1. The link between the previous paper of the same Authors (*Model updating of wind turbine blade cross sections with invertible neural networks*) and the present one should be better highlighted, and the differences clearly stated. As far as we have understood, in the previous paper, only the final sectional properties are considered, while here the blade model is more complex and comprises detailed sectional descriptions. Moreover, the method for replacing the sensitivity computations (see sec. 4.5) is new.

**Finally, probably the word “beam” in the title indicates a simpler blade model with respect to that used in the work which is characterized by a fully three-dimensional description. Please, check.**

Input:  $E_{11,UD}$

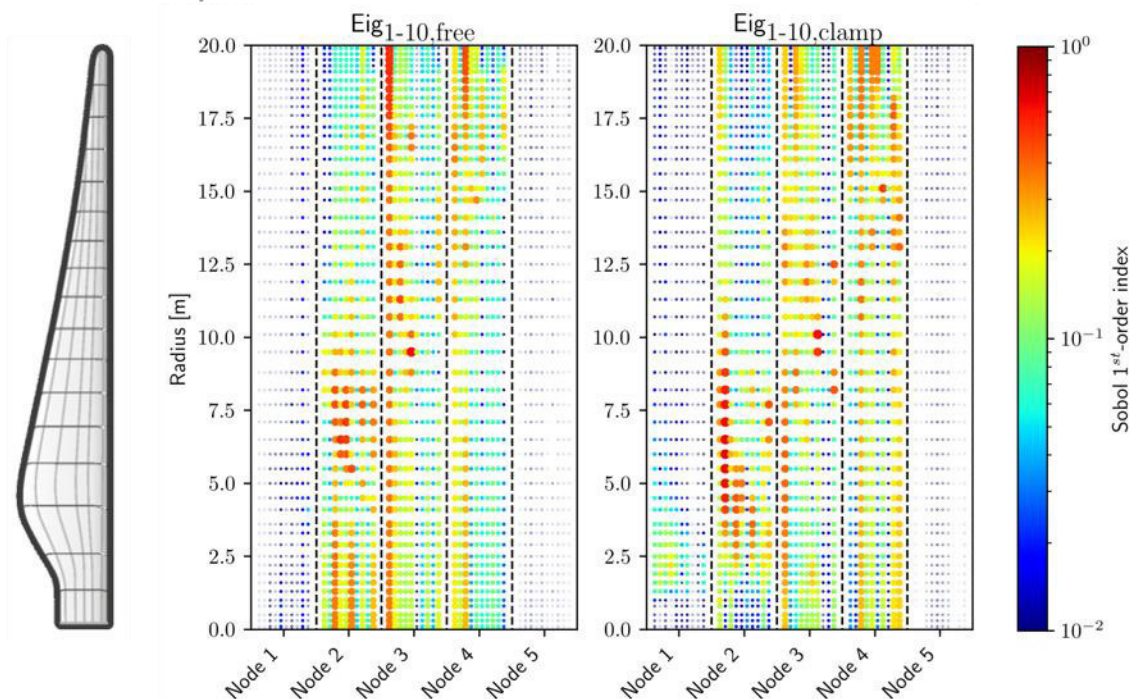
- **Tab. 2: It would be interesting to plot Sobol indices as function of the blade span, parameterized with respect to the typology of the element, so as to give an idea on how the observability changes as function of the blade span. The Author may try convert the table into a plot.**  
*Although we have already suggested in a previous comment in the interactive discussion to plot the sensitivity matrix, which connects to the stated suggestion here, we have tried several plots. However, putting all information into one plot was impossible, while maintaining a good readability and providing an interpretable plot. For several presentations, which have been prepared on that topic, we could only come*

up with a plot as shown below. But this only represents one input spline, i.e., 5 Nodes, of a total of 33 splines.

Just for the understanding of the plot: The figure shows two plots, one for the modes shapes of the free vibration (left) and one for the clamped vibration (right) for the  $E_{11,UD}$  parameter. Each plot is divided into the five nodes of the spline along the x-Axis. For each Node the 10 mode shapes of each configuration are plotted over the radius (y-Axis). That means each points represents one finite element node of the beam for the respective mode shape. However, it was still necessary to collapse the dimension of the DOFs, i.e., each point only takes the maximum value of the 1<sup>st</sup> order Sobol index of all 6 DOFs of that finite element node.

Therefore, in the end it would have been either too many necessary plots or too much information to condense into one plot. That is why we have to apologize and refrain from trying to visualize the sensitivity matrix. We hope this finds your approval.

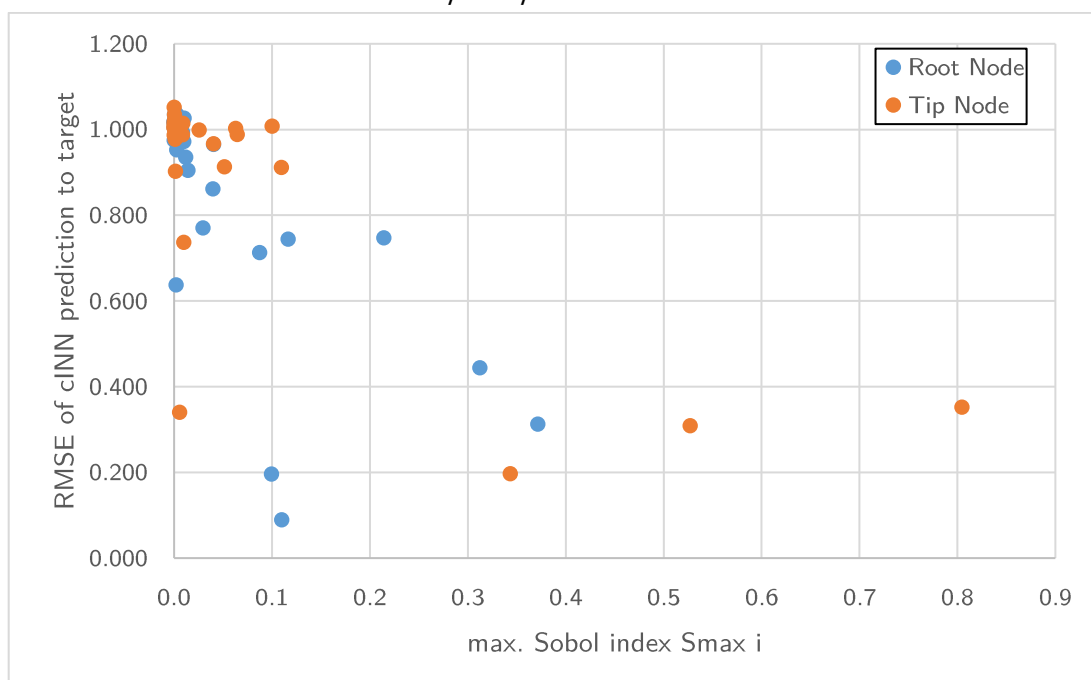
- Fig. 15: The analysis underlying this plot is interesting. I was wondering whether a similar conclusion can be derived from the Sobol analysis of Sec. 2.1. I guess that features belonging to blade root and tip be associated to both lower estimation accuracy (see Fig 15) and lower Sobol indices (from Tab. 2). Please, verify and comment.

*Interesting idea. Parting from the point that the root and tip node of the variation splines only contribute to one respective side of the variation spline and the intermediate nodes to both sides, one could expect that these tip/root nodes have less impact on the modal response and thus on the sensitivity matrix. This would imply that the mode shapes include less information for the updating process. So your anticipation is most of the times right, but it does not hold necessarily for all cases, especially for the root nodes. By having information of the clamped and free vibrating configuration, it is possible to recover information on density (free vibration) and stiffness (clamped vibration) in the root section. However, we do not have this configuration for the tip section, thus here especially the density can be better recovered than the stiffness, as the tip has no boundary condition. What in most cases is visible is that the significant sensitivity indices move from root to tip with the node number of the parameter splines. The figure provided for the previous comment, shows clearly:*

- Node 1 (0m) can be found in the clamped configuration only contributing in the root section
- Node 2-4 higher impact on their particular position (5m, 10m, 15m) but also contributions to the rest
- Node 5 (20m) basically no contribution.

*And comparing to the cINN prediction on the basis of RMSE to the target values, the figure below shows, what you have expected for most of the cases: Root and Tip Node have low Sobol indices and also poor predictions of the cINN.*

*However, as shown in the response to your last major comment, the cINN only needs one DOF of any mode shape, where the considered parameter contributes as one of the top input parameters, to retrieve enough information for the mapping of output to input parameter. Thus explains why in few cases the cINN can still compute a good prediction, although the Sobol index is low.*

*We hope this answers your question or better confirms your anticipation. However, if you agree, we would still leave this analysis out, to not over inflate the presented study.*
